Our ref: UAM-NRC-06-004

Subject: Docket 71-9239, Request for Revision to Certificate of Compliance USA/9239/AF

Enclosure 1 – Description and Justification of Proposed Changes

Figure 1 Evaluation with no added absorbers for enrichment in U-235 4.65 to 5.00 wt. %

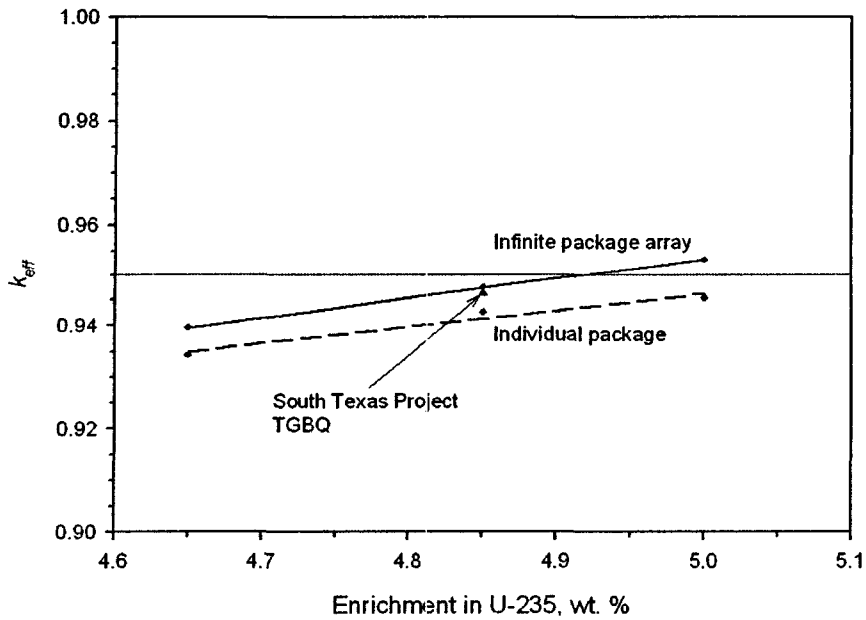
The 17XL (STD) type fuel assembly enrichment in U-235 may be increased above 4.65 wt.% up to 4.85 wt.% in the MCC package without the optional Gadolinia plate. The maximum calculated keff for an infinite array of MCC packages with a 17XL type fuel assembly enriched in U-235 to 4.85 wt. % is 0.9475. The actual South Texas Project fuel assembly TGBQ at 4.85 wt.% with 7 inch 2.60 wt. % annular pellet blankets is 0.9462.

The 17XL with no added absorbers, "single Gd plate", is evaluated at 4.85 wt.% and 5.00 wt.% and the results summarized in Table 2 and Figure 1.
